Access Compliance Report Public Rights-of-Way (Curb Ramps)

Main Street: HAZARD_AVE Cross Street: HAZARD_AVE Location: NE

ADA ID: RPRK211004152731 Ramp Type: Type 1 - Perpendicular Diagonal Initial Pass/Fail: Fail Overall Compliance: No Severity Score: 2

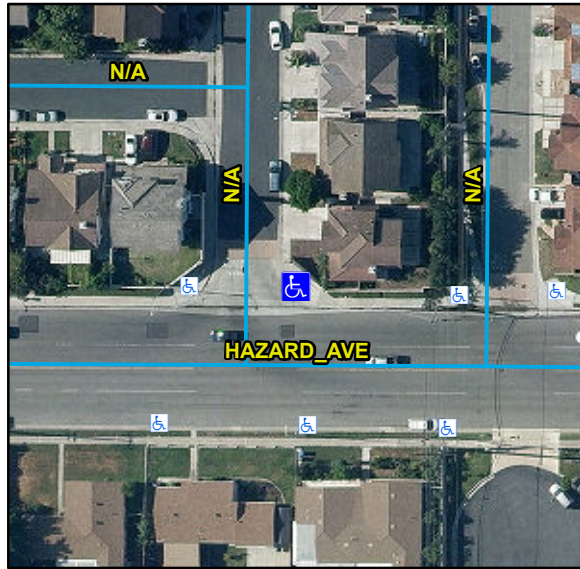
R304.2.2, R304.5.3, STD 1115

Remove & Replace Curb Ramp With Two New Directional Ramps or Equivalent.
